# 4801 FAUNTLEROY WAY SW

**DESIGN RECOMMENDATION MEETING**

FEBRUARY 18, 2016

3020235

DC2 ARCHITECTURAL CONCEPT: Develop an architectural concept that will result in a unified and functional design that fits well on the site and within its surroundings.

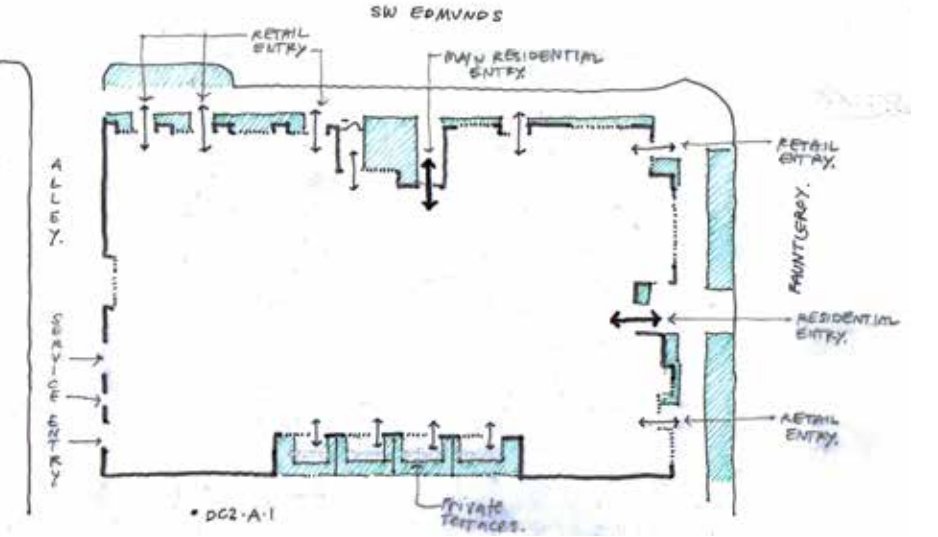
b. The intended modulation along each street front appears appropriate for the scale and size of the project. The modulation and detailing should respond to the internal programming, as well as to the varying streetscape character. (CS2-D, DC2-A, DC2-B, DC2-D)

c. The entry courtyard effectively breaks up the massing along SW Edmunds, contributing to the perceived smaller scale of the development. The Board felt that the break in massing creates the opportunity to express different, but related, design languages on each portion. (CS2-D, DC2-A, DC2-B, DC2-D)

*Response: The building steps back at the upper levels to reduce the mass at the street. At the street level, large commercial storefronts are proposed for the retail uses, with a residential entry courtyard that is differentiated from the retail in spatial configuration, landscaping, and finishes. At the upper levels, windows and openings to the mid-level roof decks reflect the internal programming (apartments).*

*Response: we have detailed the facades on either side of the entry courtyard differently, with the west portion using a townhouse/brownstone concept:*

DC2-C SECONDARY ARCHITECTURAL FEATURES

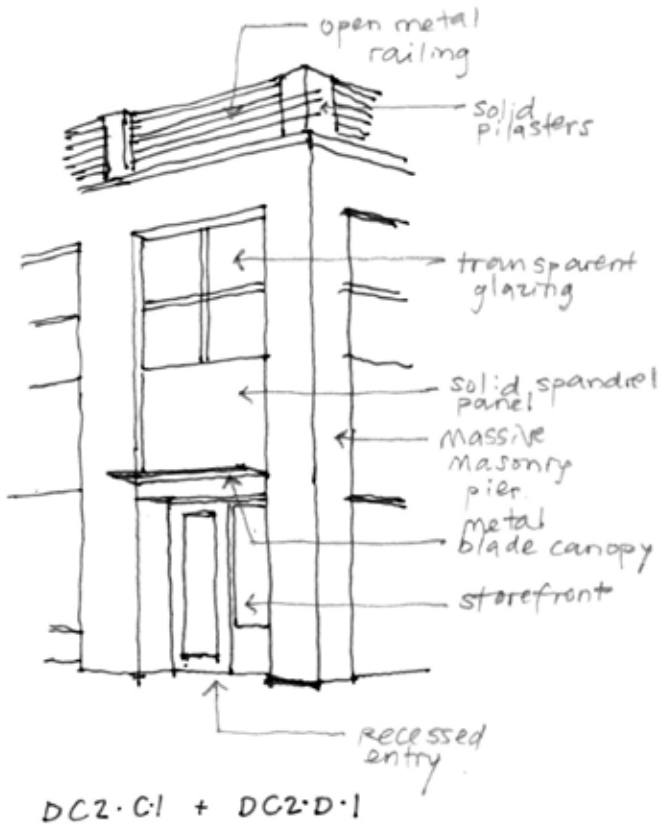
e. The Board supported the canopy as a unifying feature across the massing, and encouraged the applicant to use a simple design that relates the internal programming. (PL2-C, PL3-A, DC2-C, DC2-D, DC2-A)

*Response: We have refined the canopy design to emphasize the retail and residential entries as well as the corner of the building. The canopies vary in height based on sidewalk level, and vary in scale based on location on the facade: the west portion of the Edmunds facade has thin metal canopies located at the retail entries while the east portion of the facade has heavier canopies.*

SOUTH ELEVATION

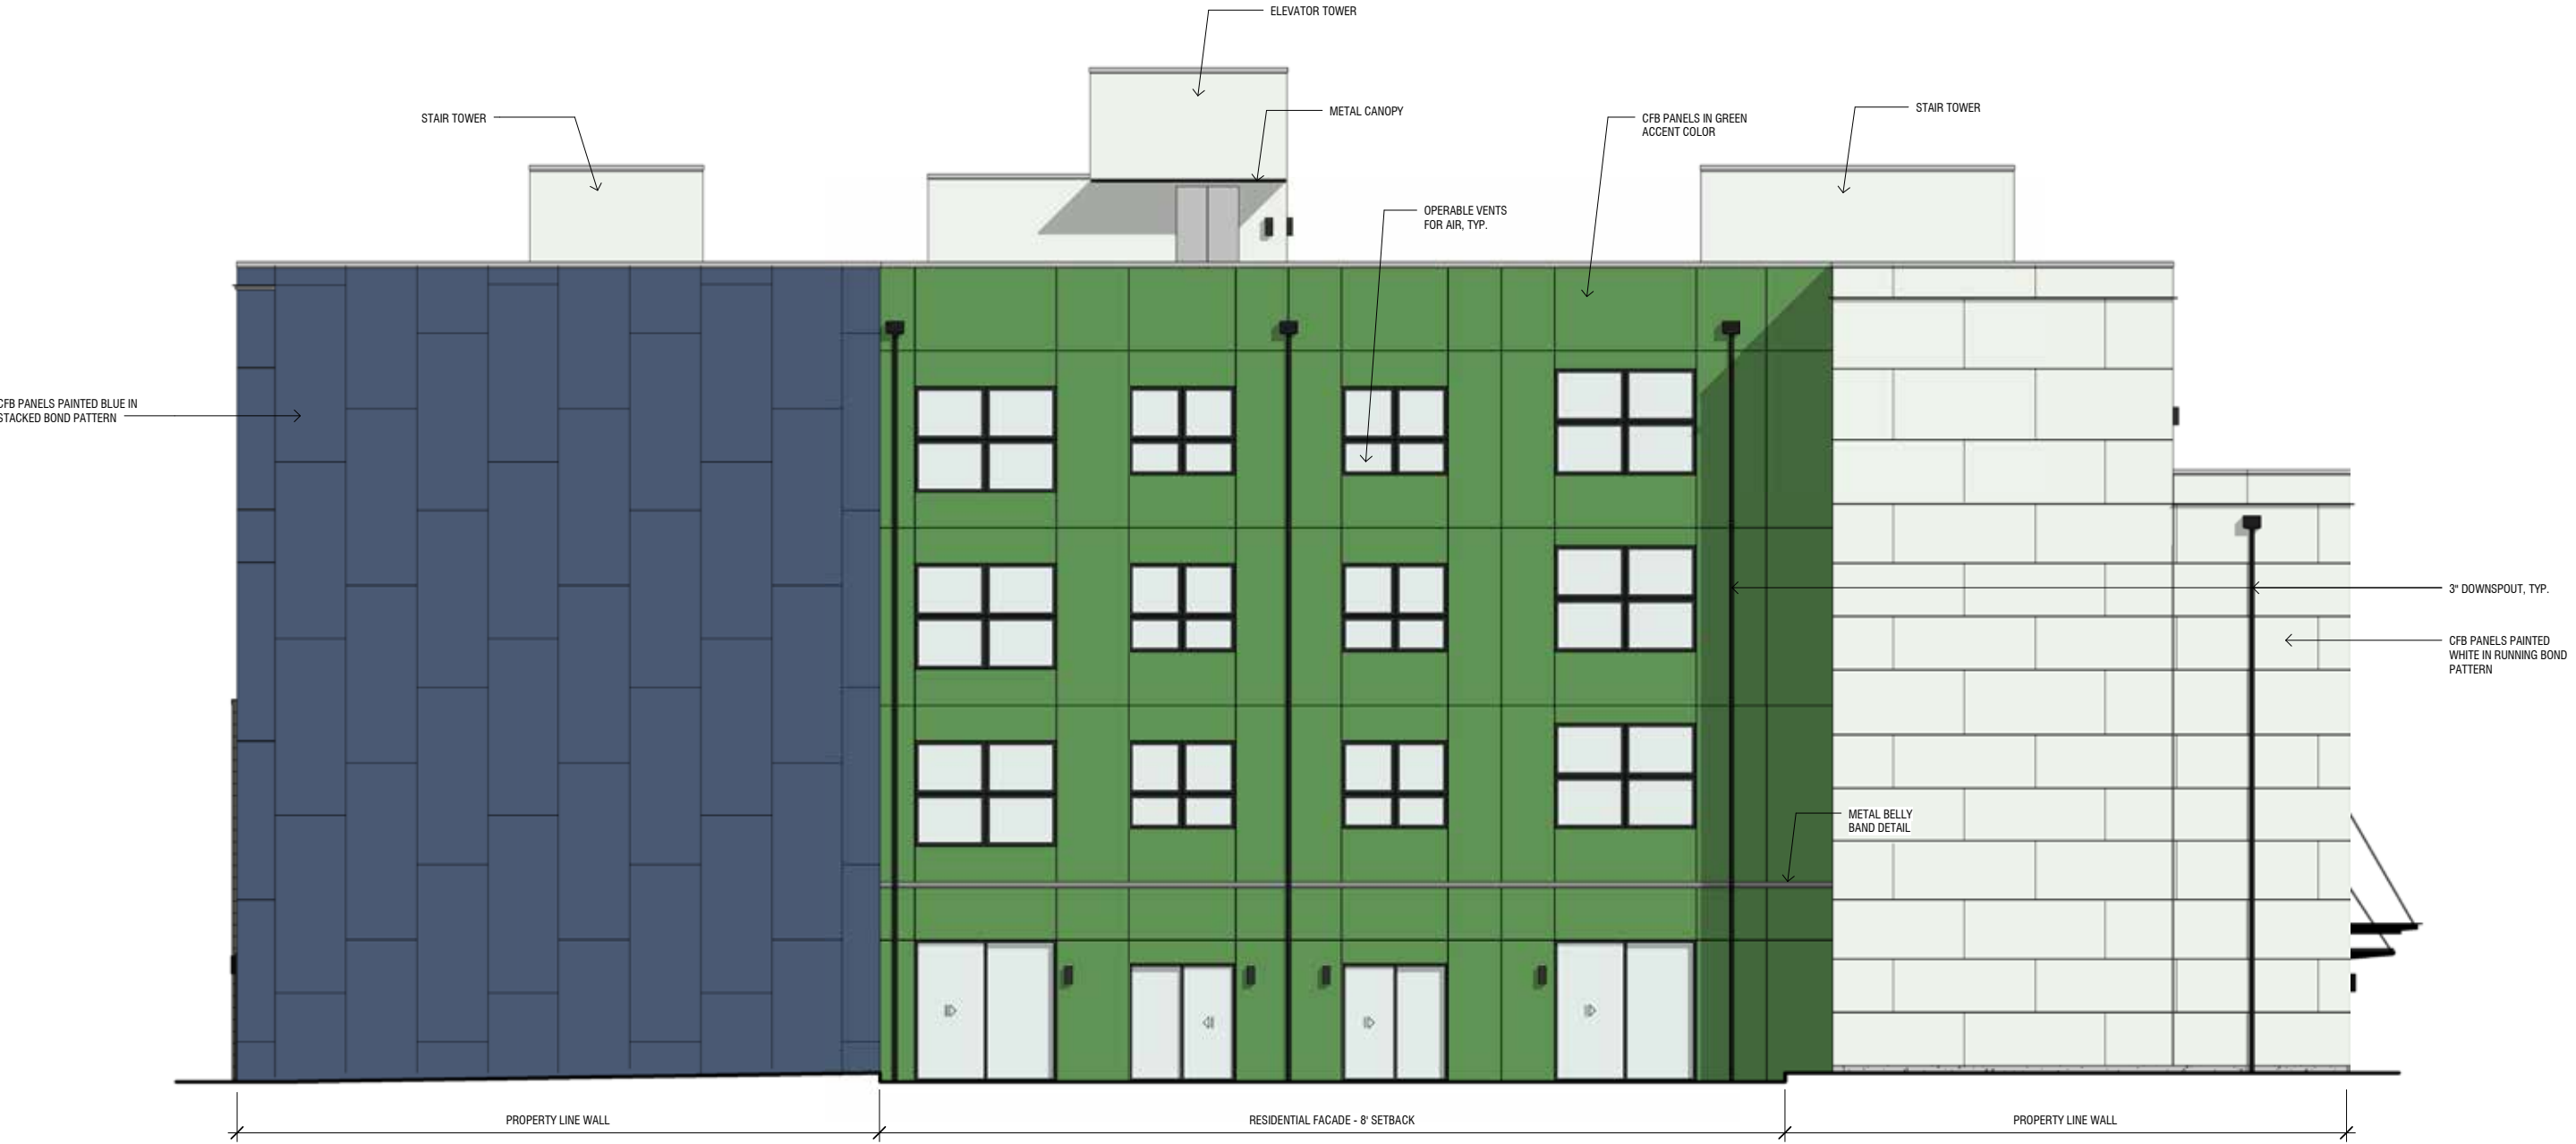
f. The Board requested to see more information regarding the treatment and articulation of the south facing and alley facing façades, noting that any materials and level of articulation on any blank walls should be carefully considered. (CS2-D, DC2-B)

g. The massing should be refined to provide as much access to light and air as possible. The Board suggested increasing the setback on the south facing units, and possibly creating a courtyard, to allow for more space between the units. (CS1-B, P1-C, DC2-A)

*Response: The south facing facade has been broken into three sections with different treatments.*

*The south property line walls, where openings are not permitted, have received a pattern treatment using cement fiberboard panels to provide wall texture and break up the scale. The middle portion is stepped back 8' and has a regular fenestration pattern in an appropriate scale. The south facade will be treated with pattern and color to minimize its impact.*

*Response: The middle portion of the south facade has been stepped back an additional 3' from the original scheme (for a new setback of 8') allowing additional sun exposure to the building and ground level patio areas. This increased setback will reduce the perceived overall mass of the building and also gives a deeper shadow line to help reduce scale. The proposed setback is the maximum possible in order to make the interior double-loaded layout work.*

1 E-W SITE SECTION

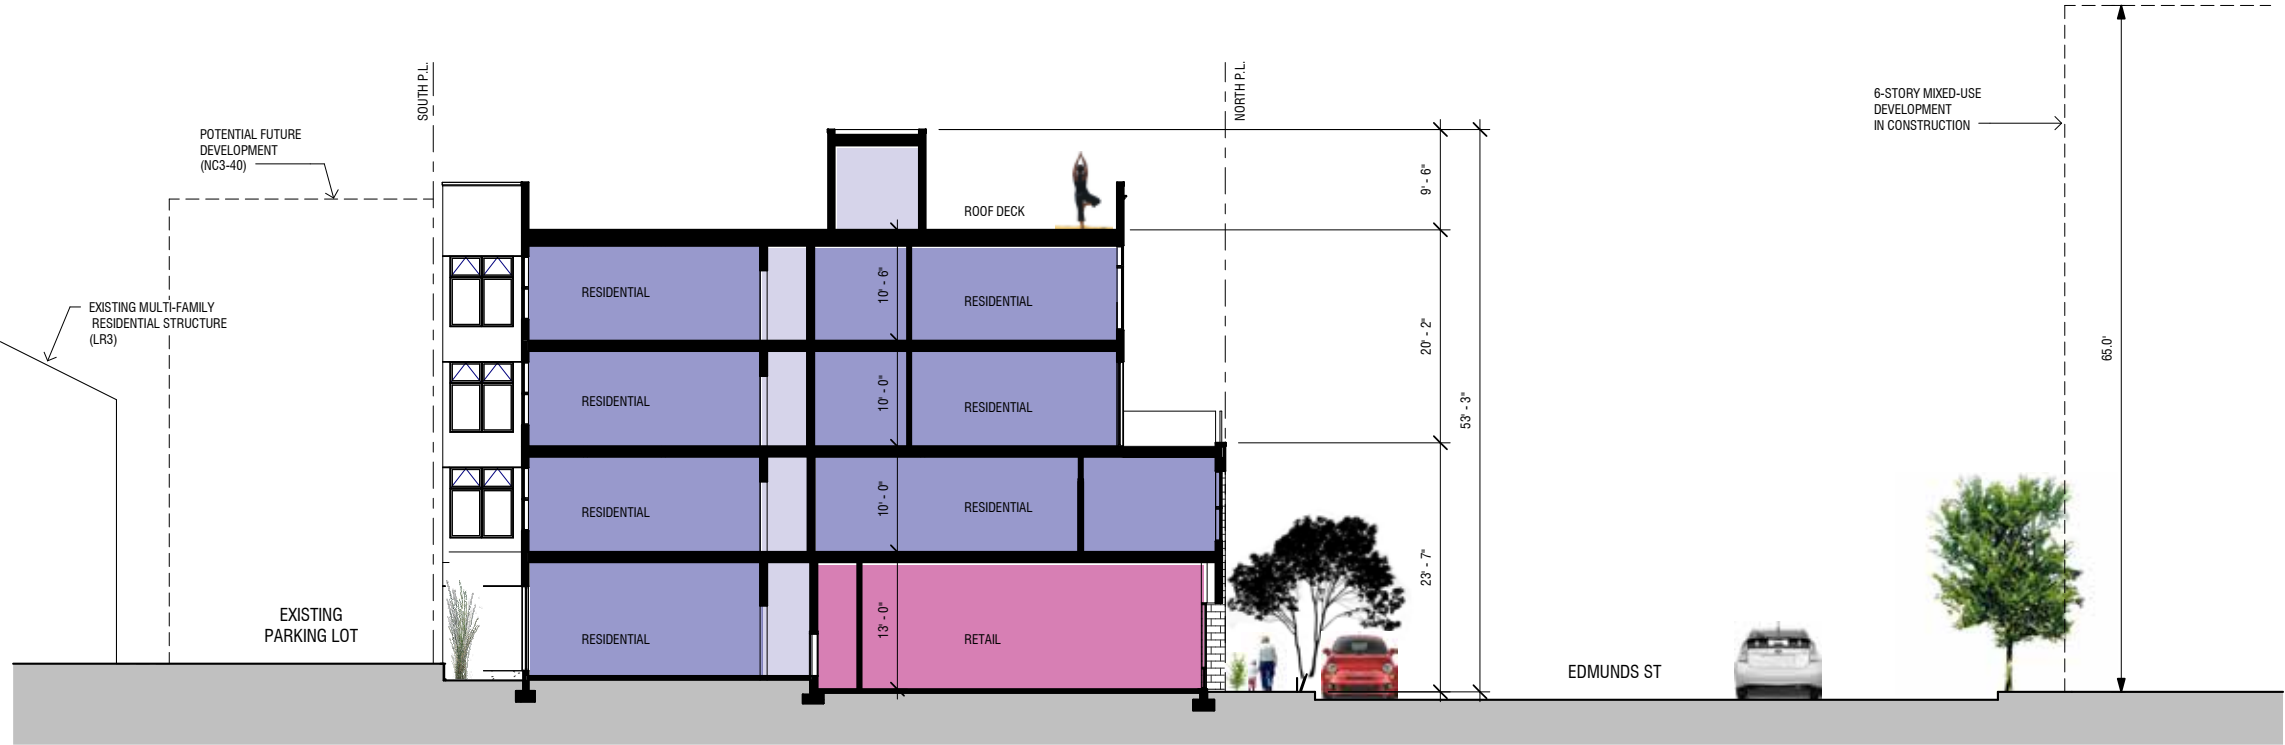
a. The Board felt the massing provides an appropriate transition in scale and character from the large scale development to the north to the residential scale of the Lowrise zone to the south. (CS2-D)

*For an evaluation of adjacent development potential, see site section diagrams on pages 46-47 of this packet and perspective diagram on page 10. The site has identical zoned parcels across the alley and to the south with public right of way to the north and east.*
